### **HISTORIC DISTRICT REVIEW BOARD**

Wednesday, September 9, 2020, 2:00 P.M.

B. 1307 Bay Street, Addition

A. 809 Port Republic Street, New Construction

**NOTE: RIDGE OF NEW SHED ROOF STARTS AT ROOF RIDGE OF MAIN HOUSE**

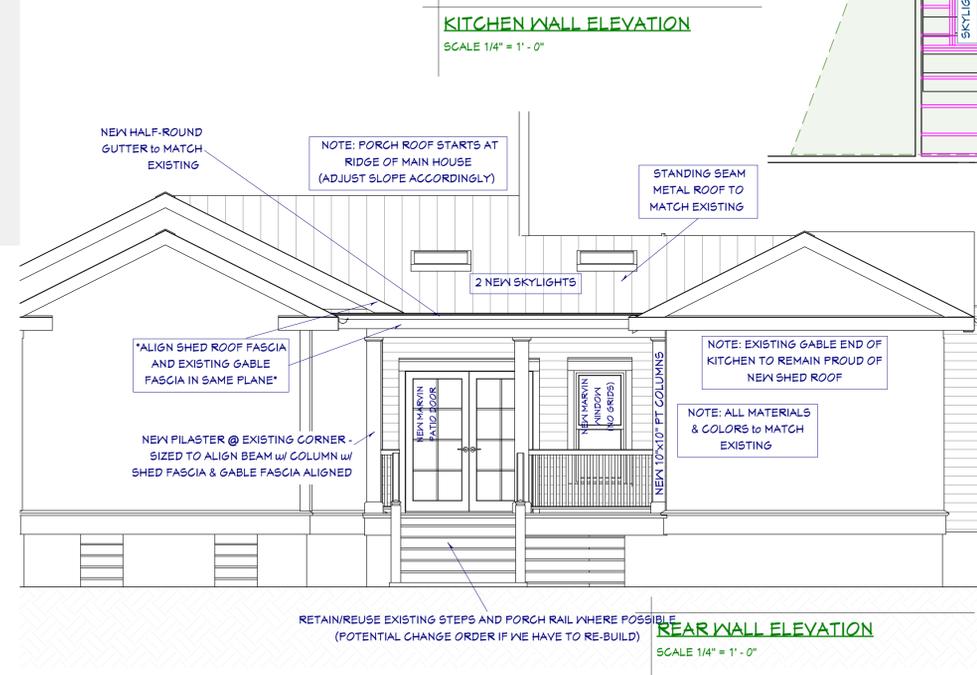
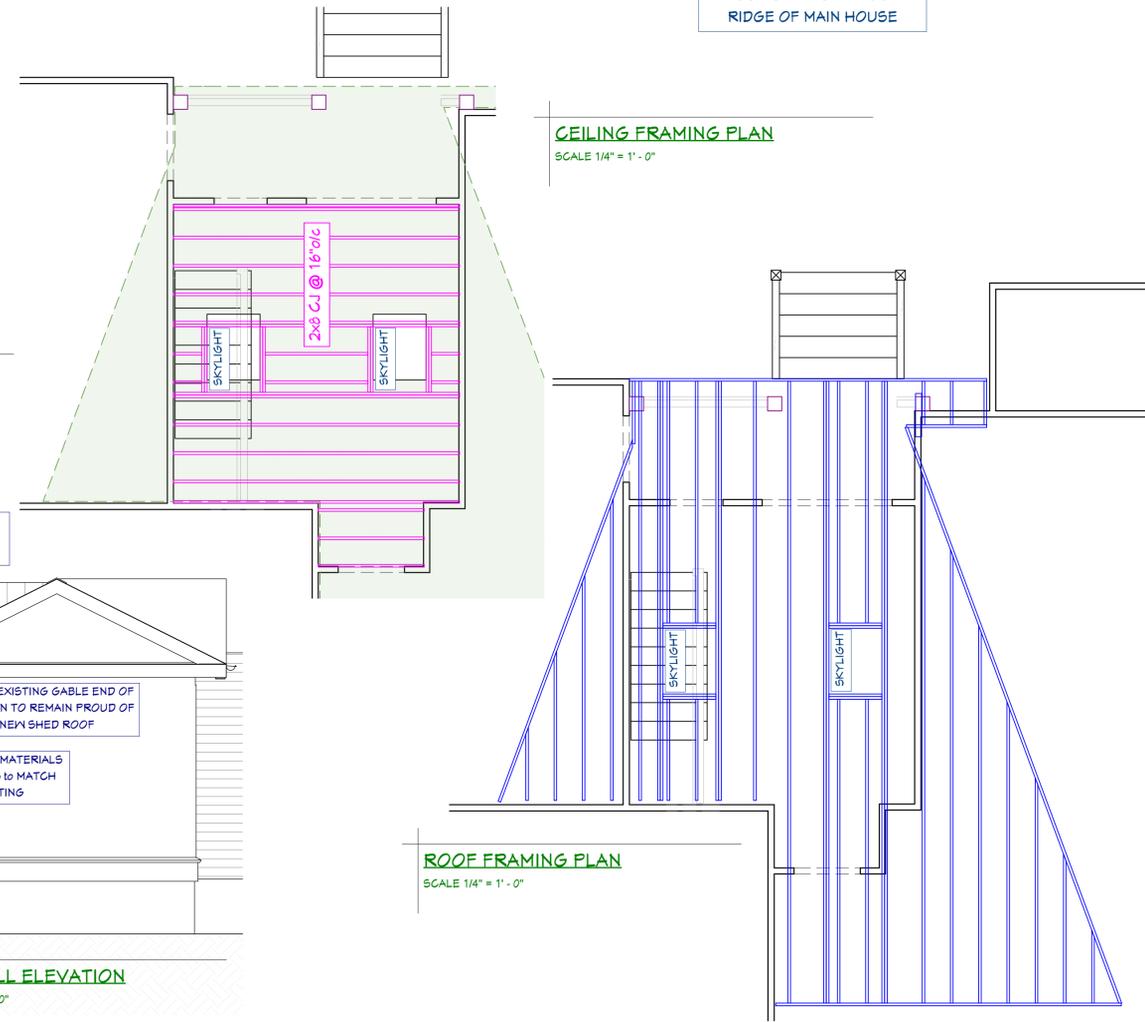
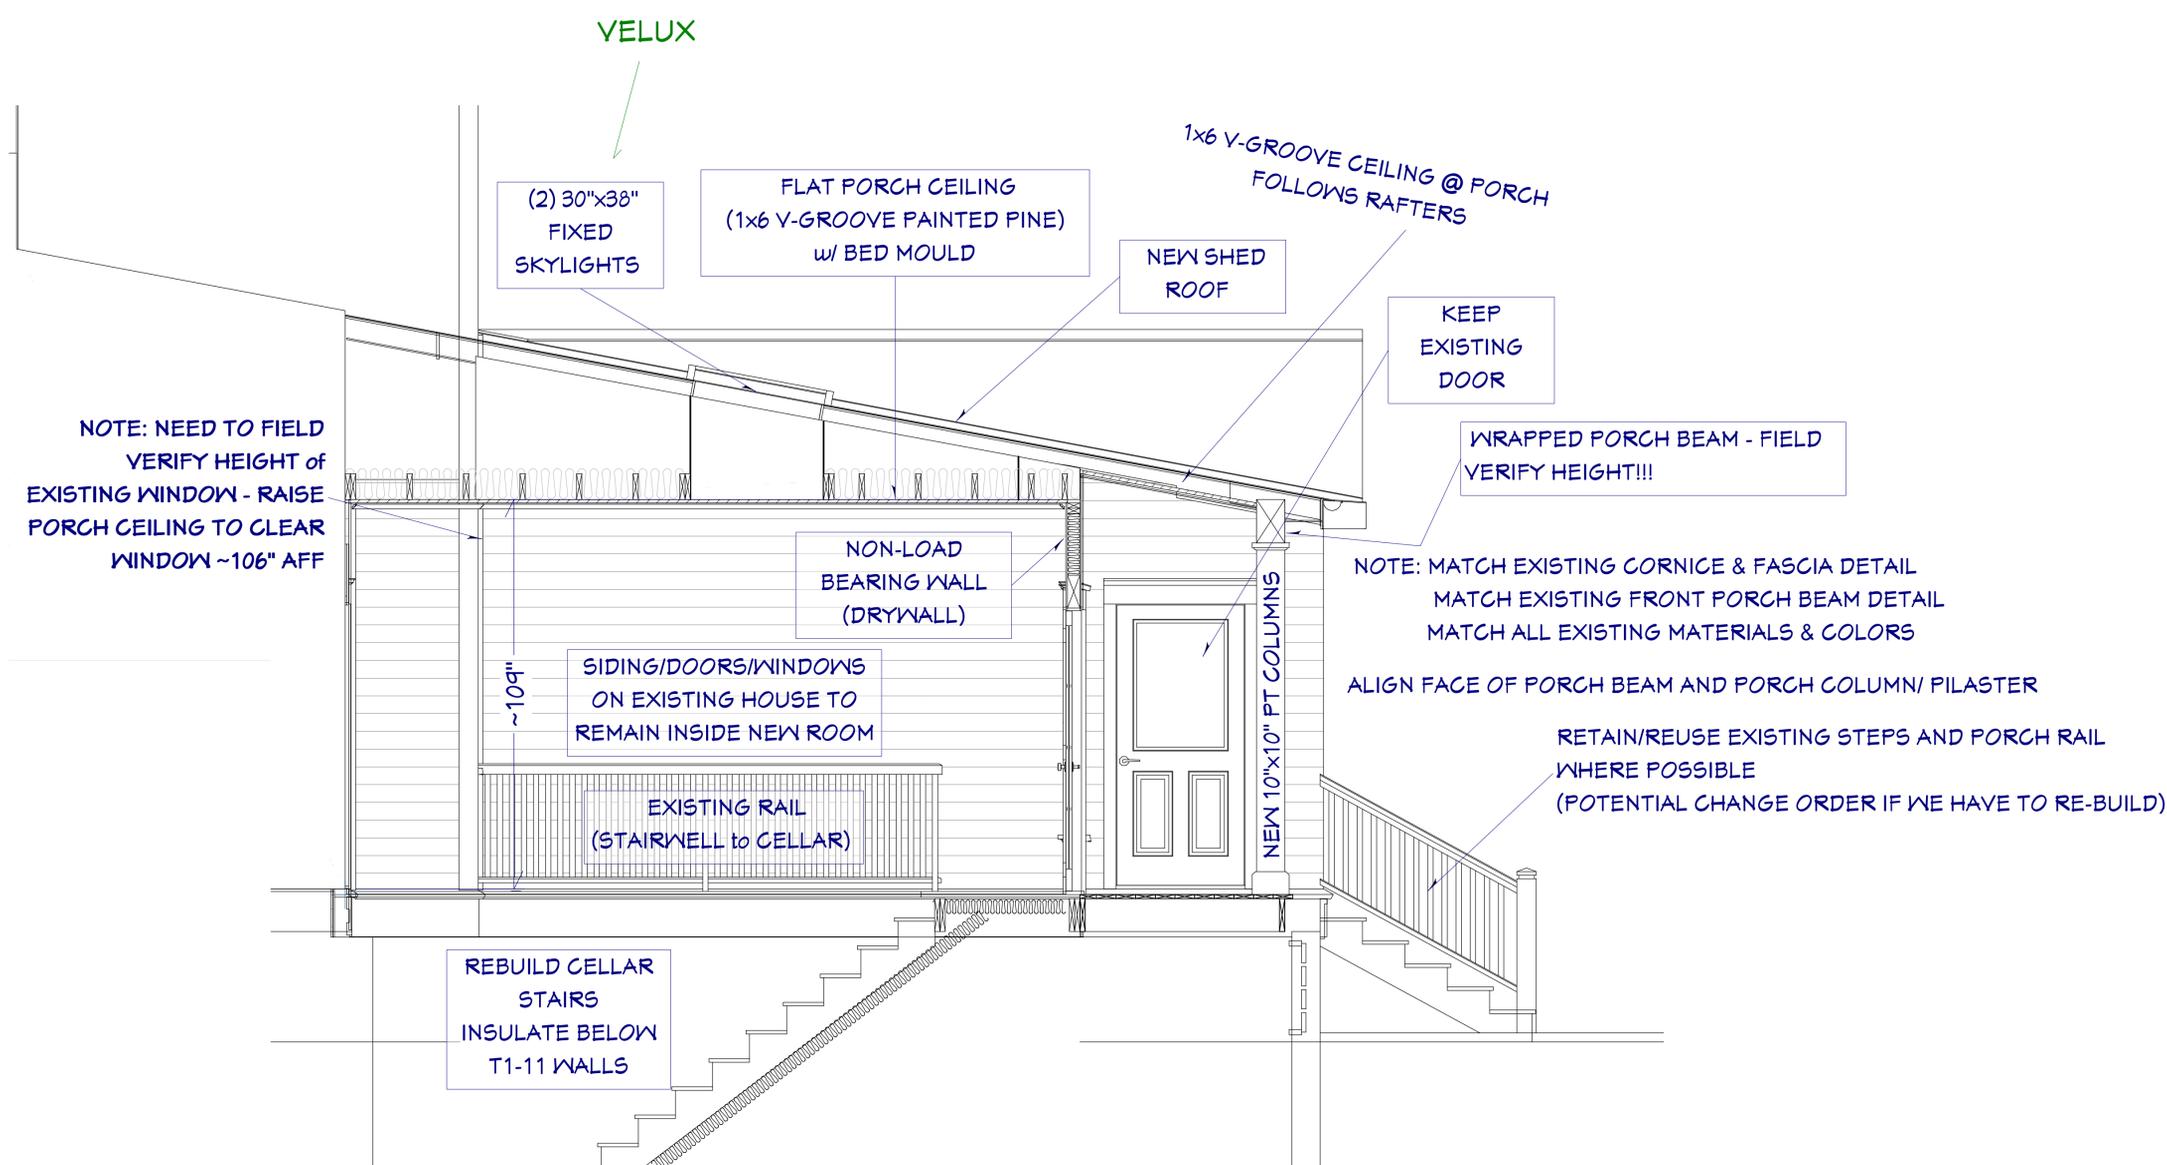
1. The applicant met with staff to review the project in depth before submitting for final review.
2. The applicant has aligned the new shed roof fascia board with the existing gable fascia on the east side so that they are in the same plane. The kitchen gable will remain proud of the addition. Staff believes this is a positive solution for this area given that the two existing gables do not currently align.

3. The applicant has clarified that the new shed roof pitch will be set at 3"/12", but will be worked out so that the fascia board of the new shed and the existing master gable aligns as noted in the comment above. Staff finds this approach to be acceptable.

1. We will align the new Shed Roof Fascia with the existing Gable Fascia (same plane) to the East Side. Kitchen Gable will remain proud of the addition.
2. We will start at the existing main house ridge and work backwards to the Porch Beam – setting the Shed Roof Pitch at ~3/12, but working it out so the Fascia of the New Shed and Existing Master Gable Align as described above.
3. All Materials to Match Existing.
4. Velux Skylights (fixed). Marvin Signature Patio Doors & one Window as Shown on Rear Elevation.

Here is the change requested. We will just pull the shed roof back so the Gable End above the Kitchen remains proud of the porch. There was a question of roof pitch – the answer there is it will be what it is. We will start at the main ridge of the house (or below – we do not want to change the look of the main ridge), then we will build a shed roof out over the porch – the approximate pitch will be 3/12, but in reality it will likely be less than that.

We will align the new Shed Roof Fascia with the existing Gable Fascia (same plane) to the East Side. Kitchen Gable will remain proud of the addition.

Updated Site Plan  
SCALE: 1" = 20'

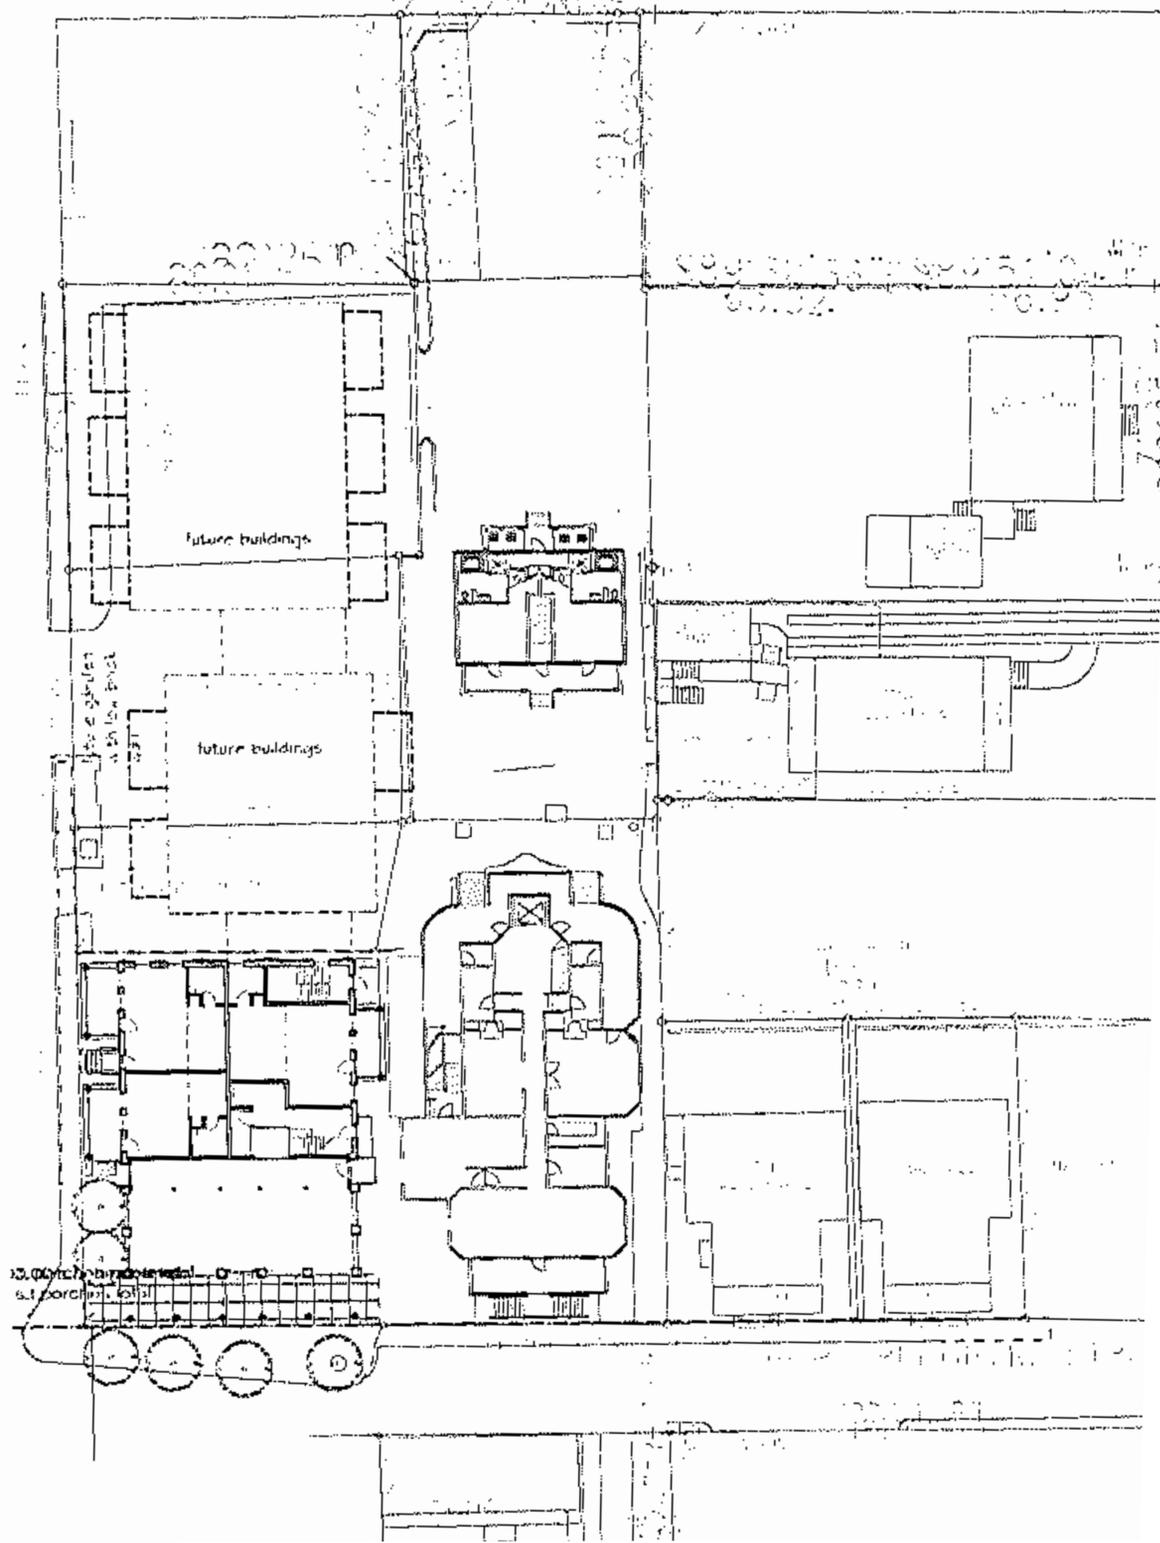
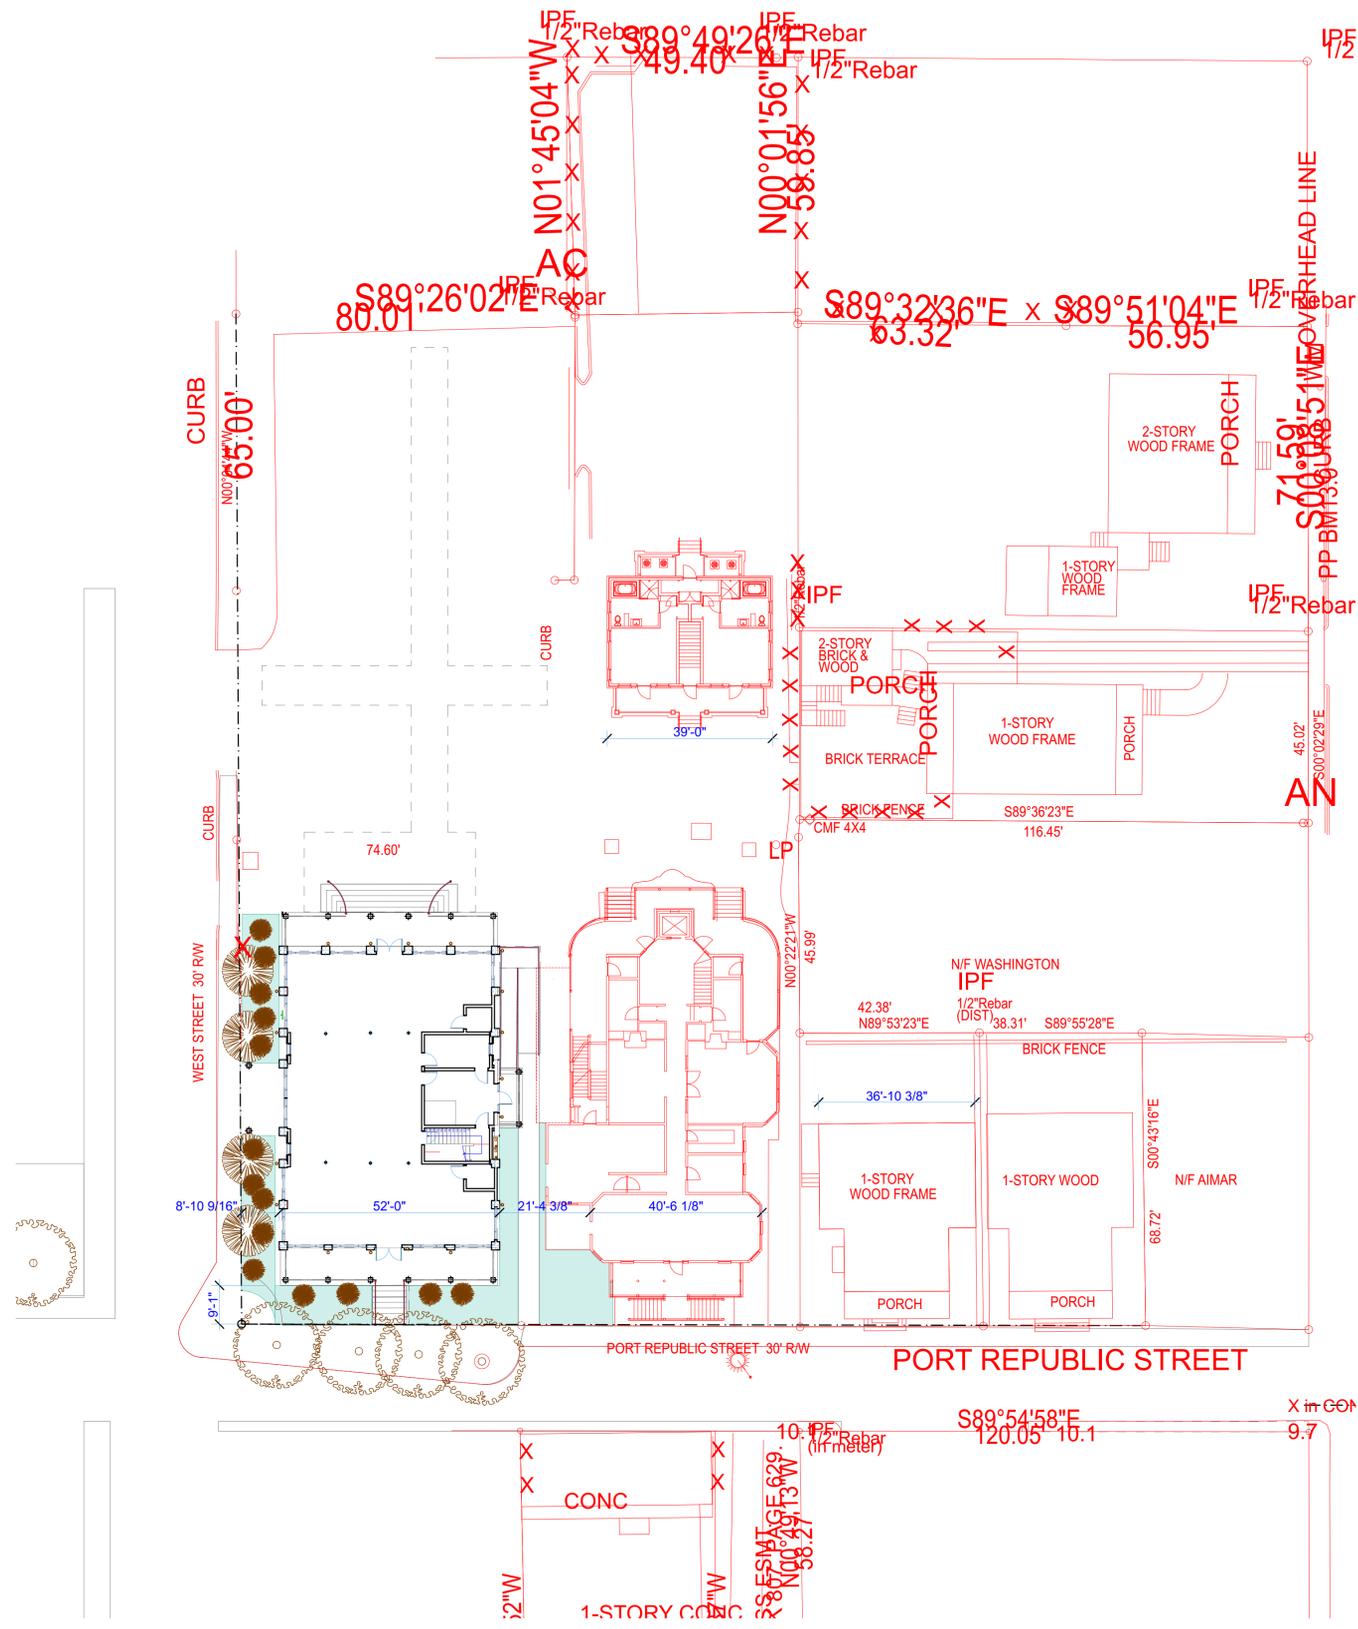
- It would be helpful to see a “previously approved” site plan next to a “current proposed” site plan so that we can understand the changes that have been made to setbacks and landscaping that are difficult to identify on elevation drawings. Please use keynotes in these plans as well. **Added scanned pdf of previously approved site plan**
